BUILDING COMPLETION REPORT

NOTICE OF COMPLETION UNDER SECTION 187 (I) OF THE
CITY OF KARACHI MUNICIPAL ACT, 1933

FINAL.
PLAN SHOWING PROPOSED
ADD: & ALTERATION IN BUNGALOW
ON PLOT NO 173 J.M.I.
JAMSHED QUARTER.
SCALE = 8"=1'

With reference to your application dated 24-7-39,
with a plan for the proposed buildings/additions and alterations on plot
No. 64 Survey Sheet No. J.M.1, Jamshed Quarter,
I have to request you to comply with the following requirements—

SECTION ON A.B.

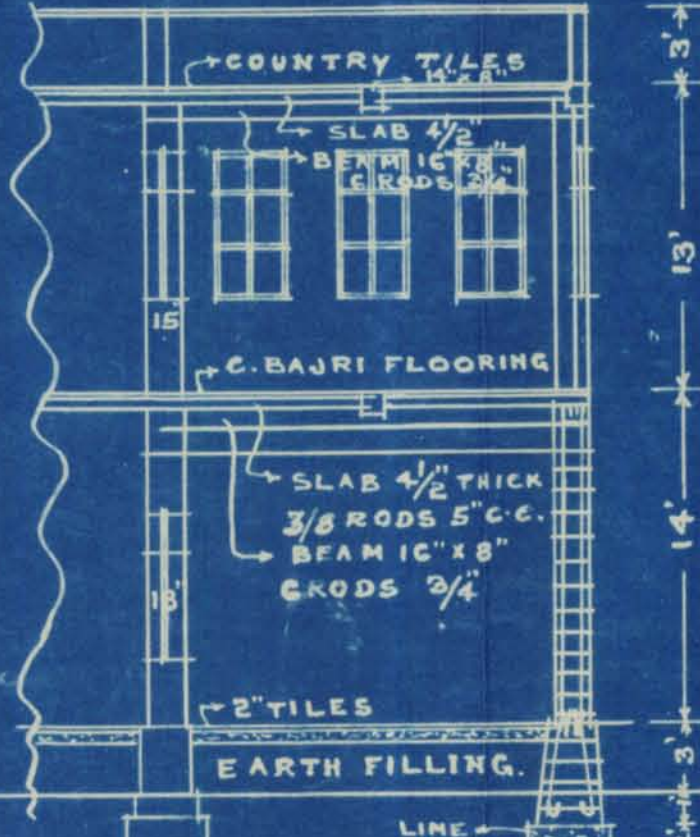
In reply to your letter No. ICP
480/38 dated 21st instant in connection
with plot No. 64 sheet J.M. I we beg to
return the plan after showing bath &
english w.c for favour of approval.

FINAL
PLAN SHOWING PROPOSED
ADD: & ALTERATION IN BURGALOW
ON PLOT NO 173 J.M.I.
JAMSHED QUARTER.
SCALE = 1" = 1'

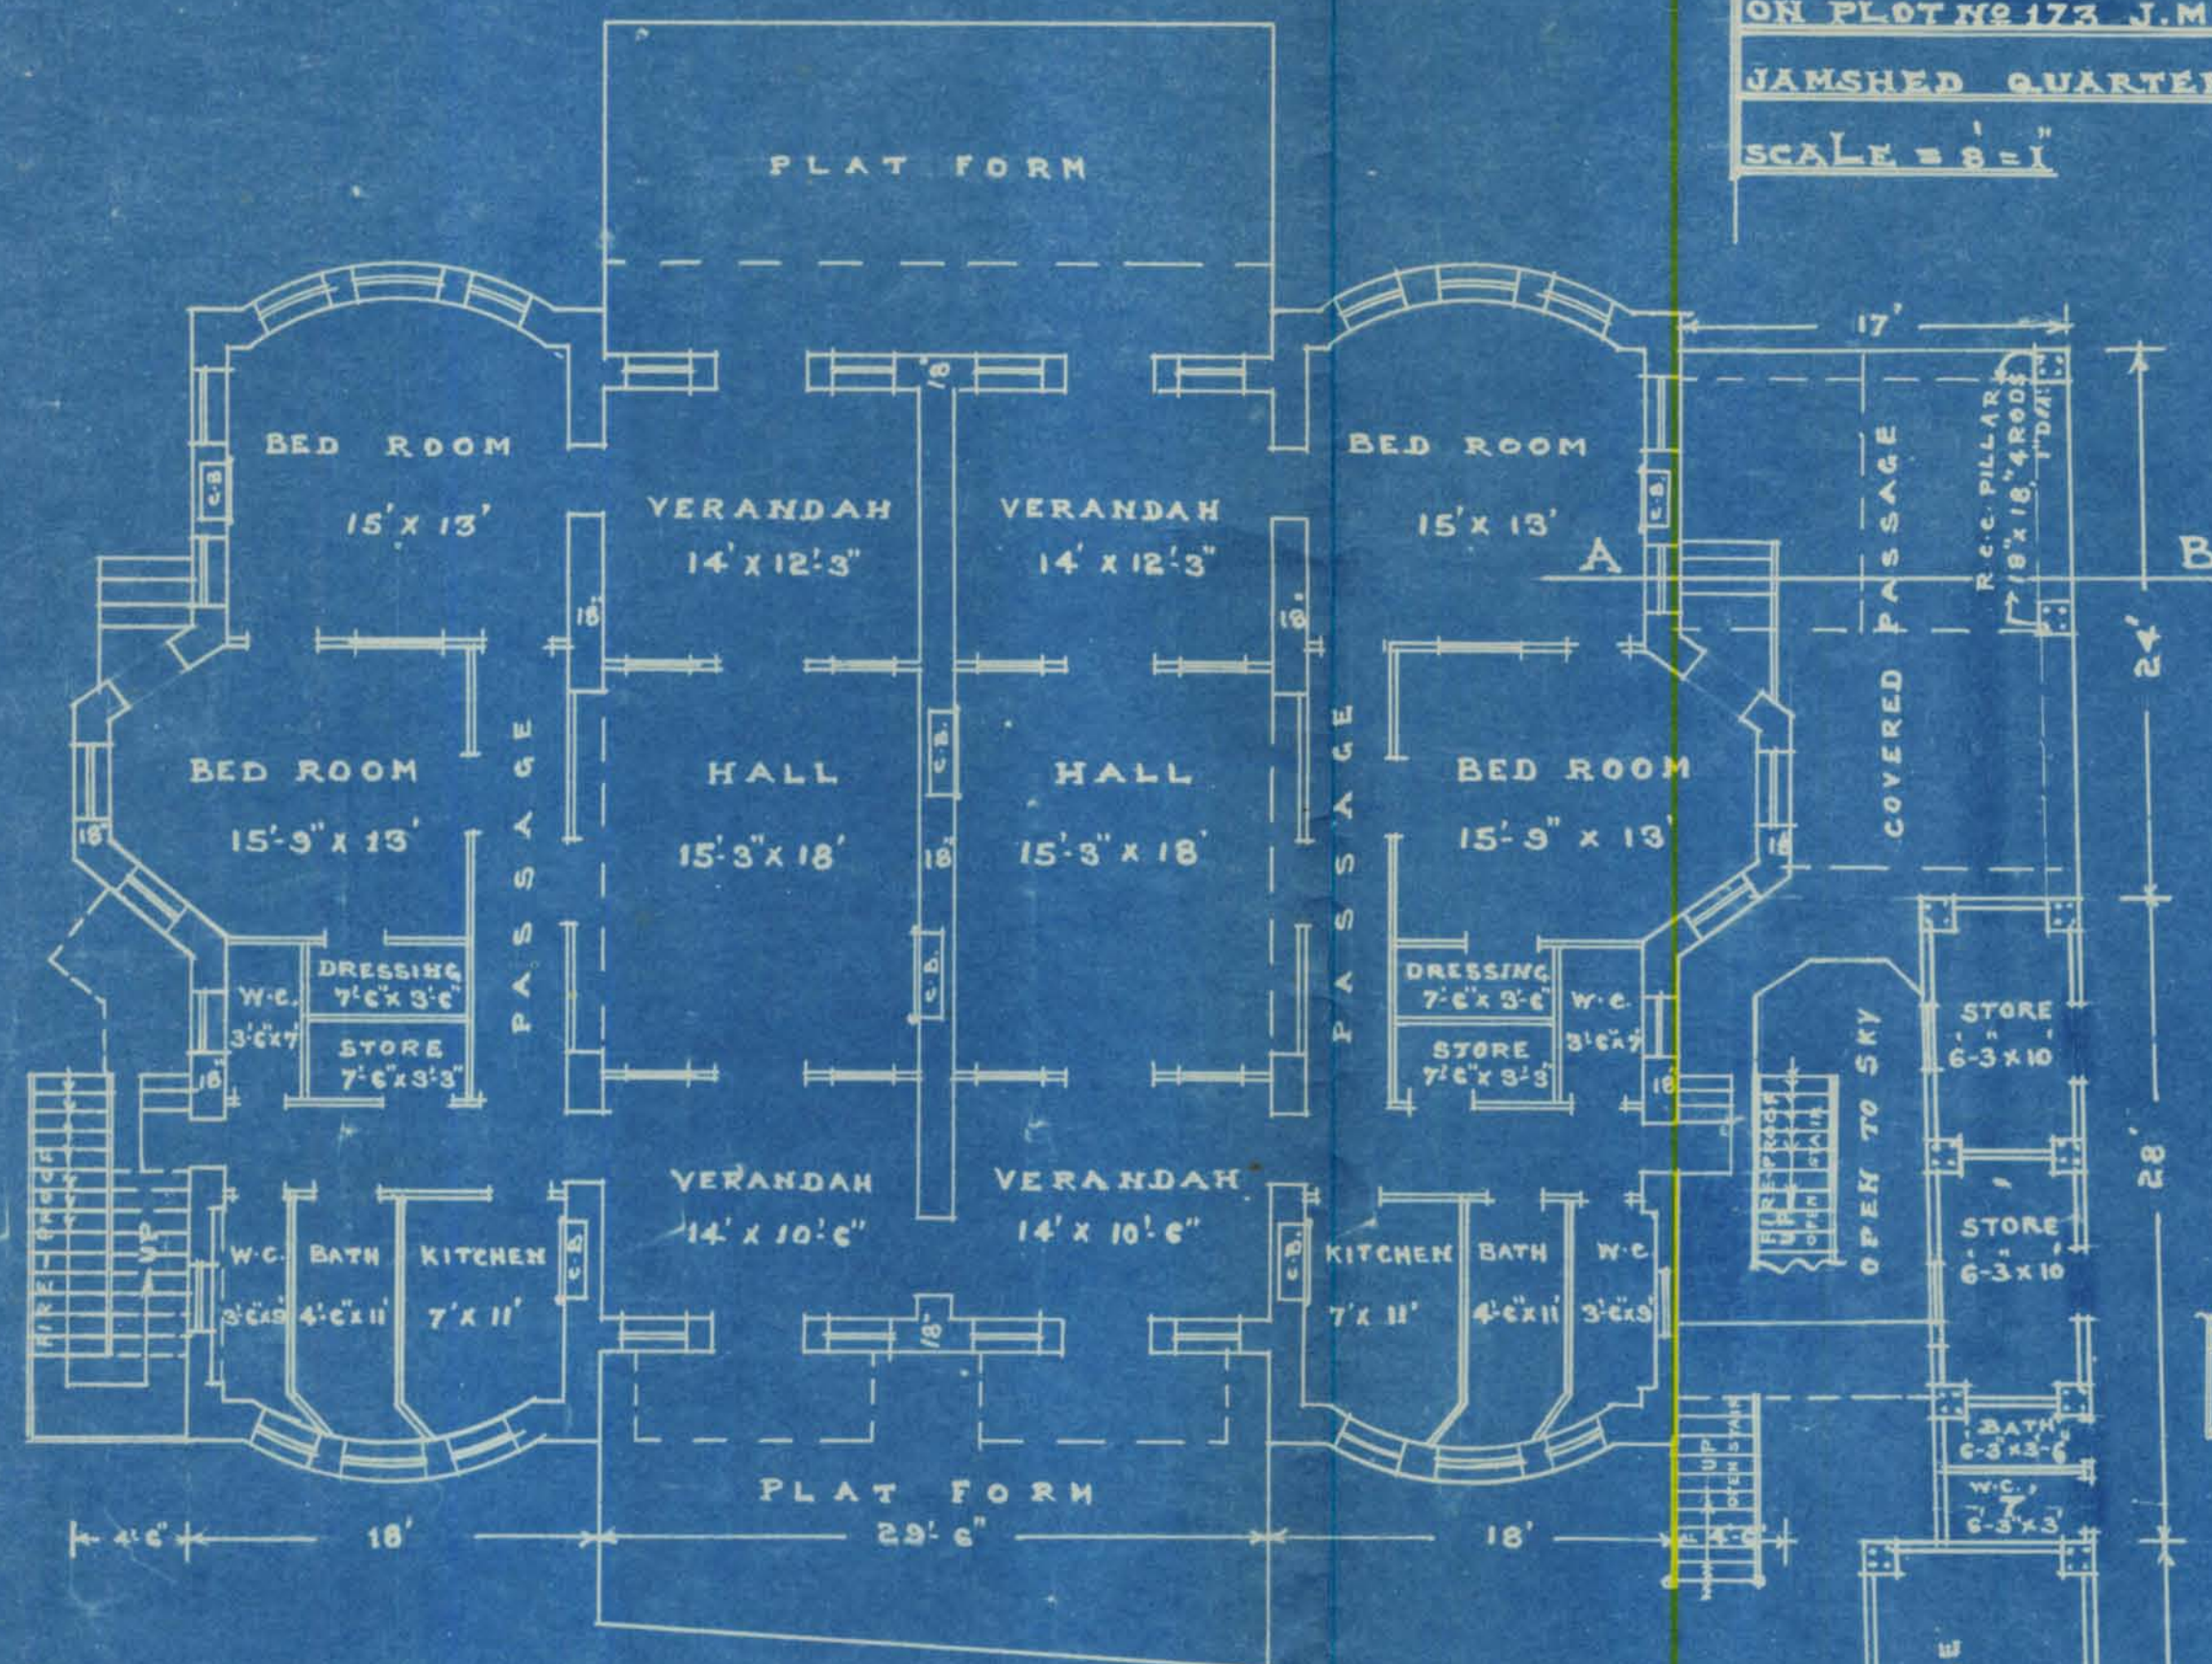
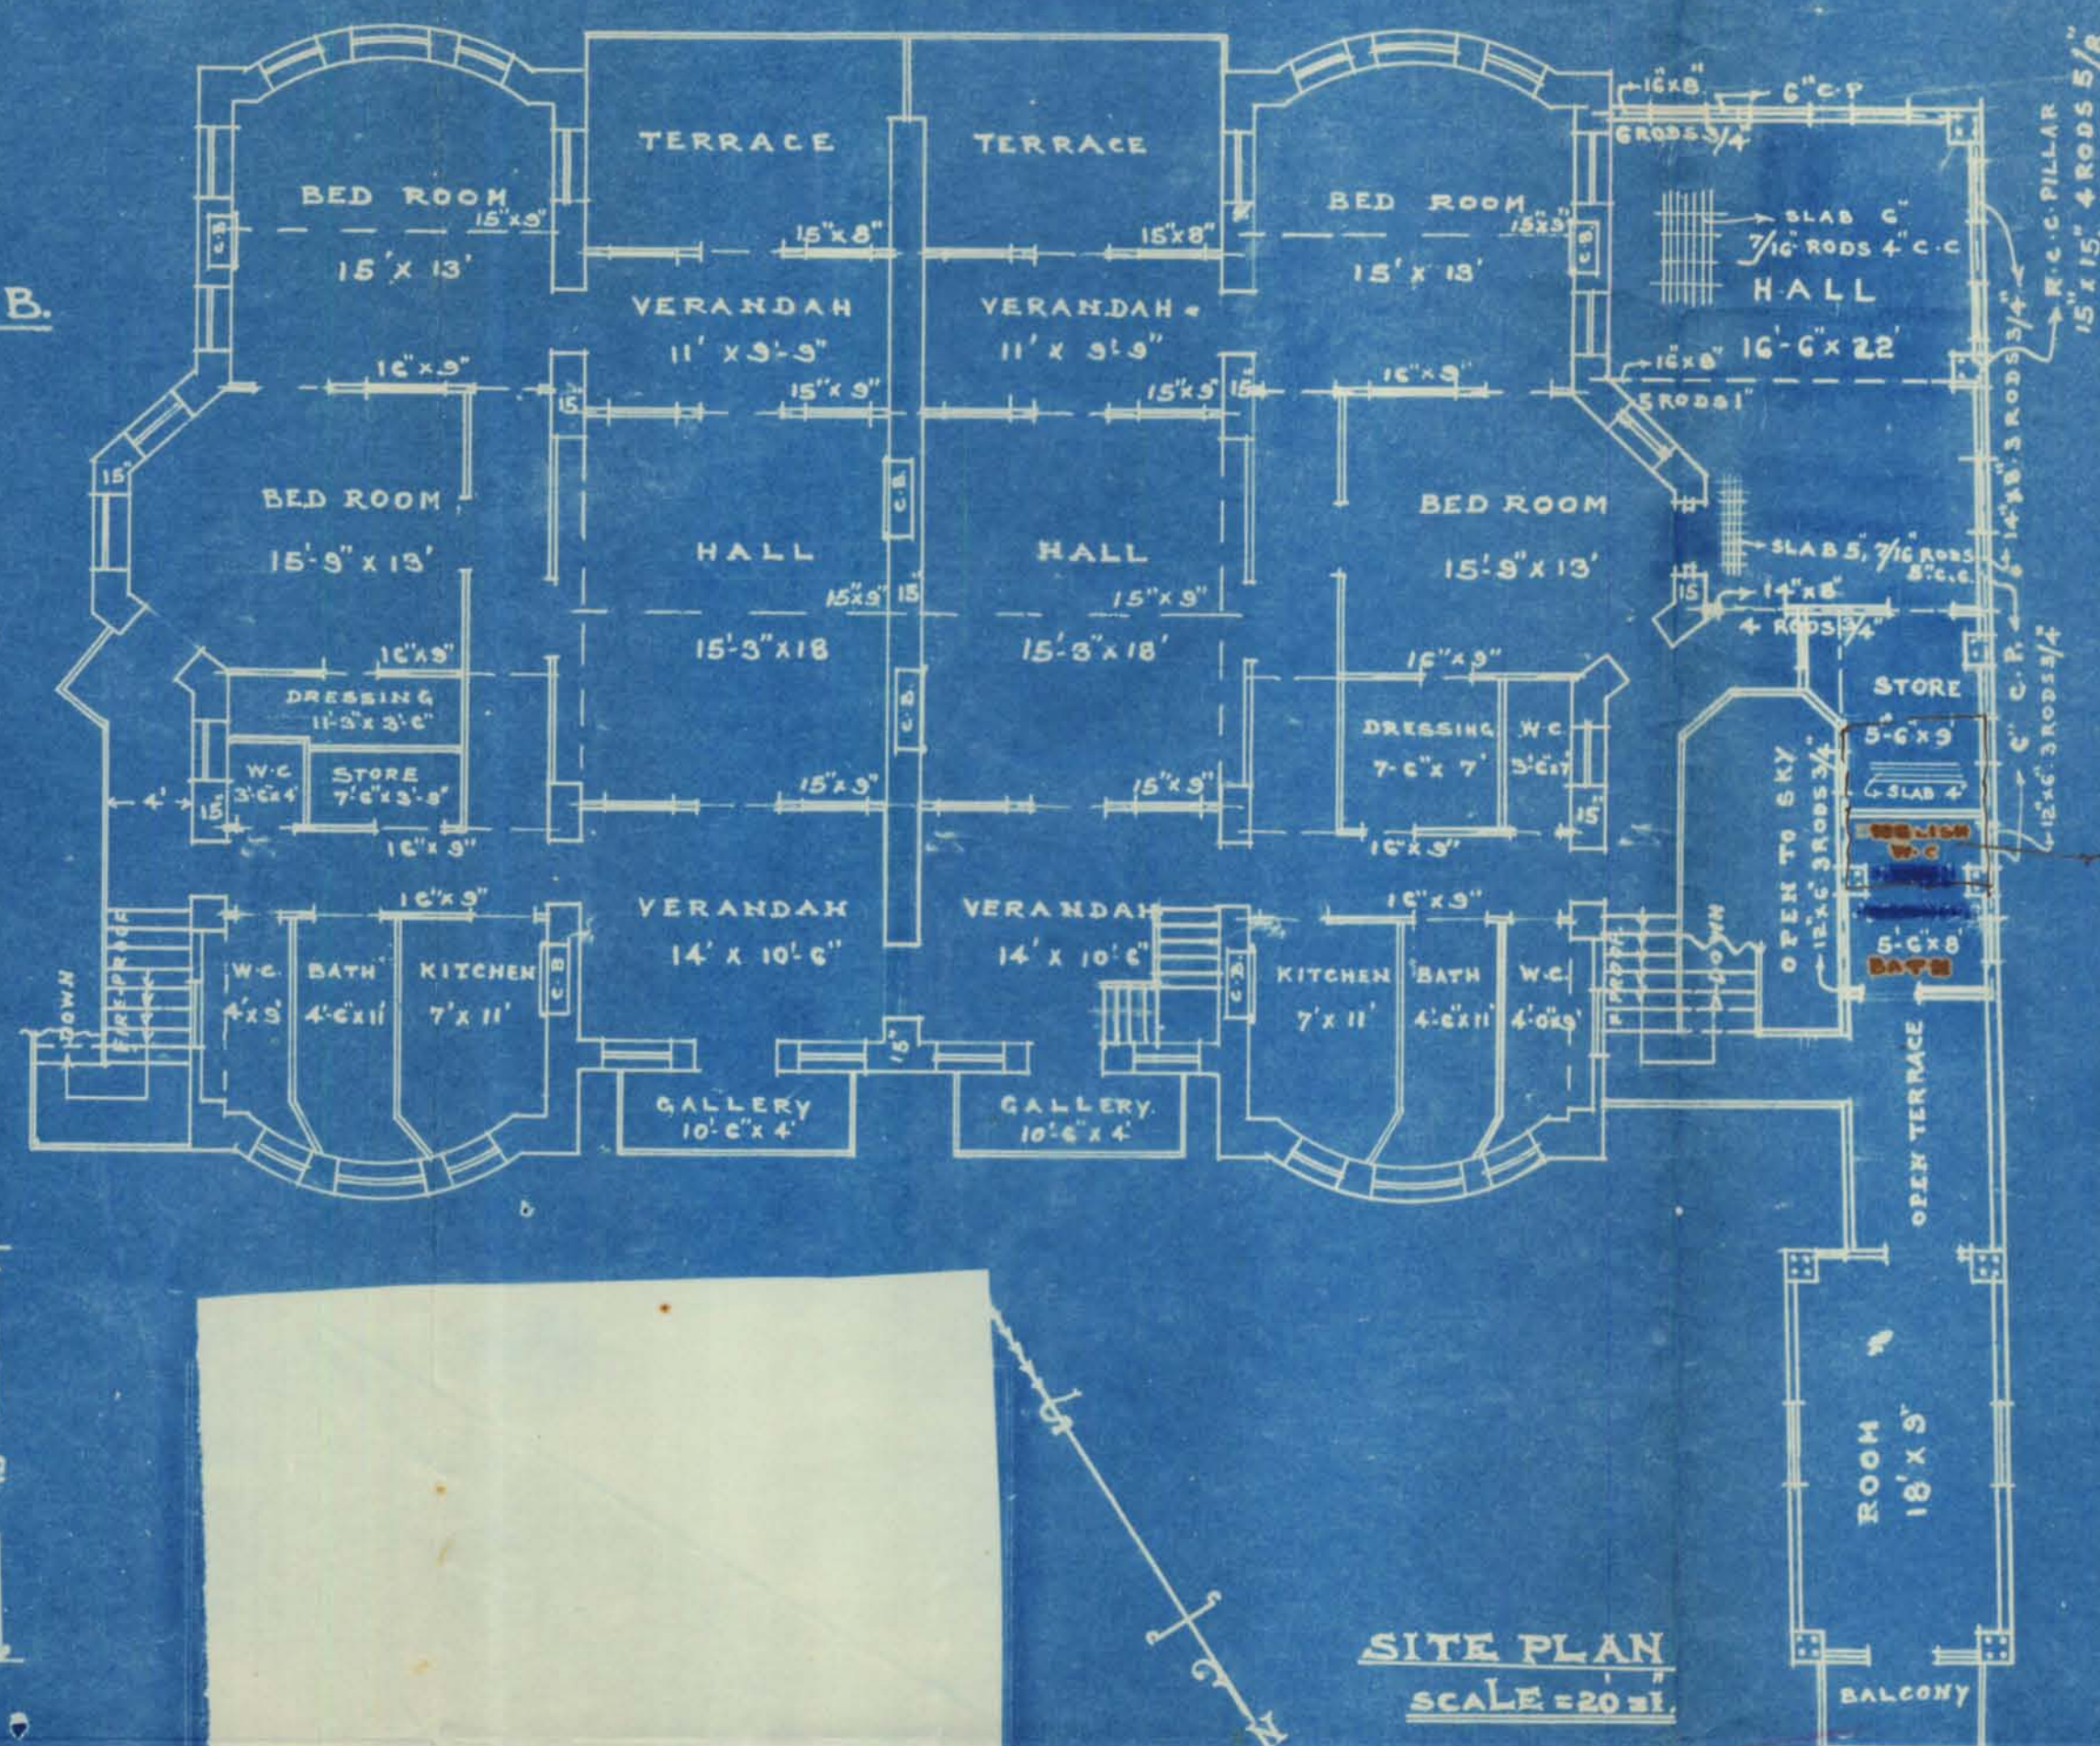
(1) Bath and commode should be converted into bath and W.C.

1. Bath & commode should be converted into bath & W.C.
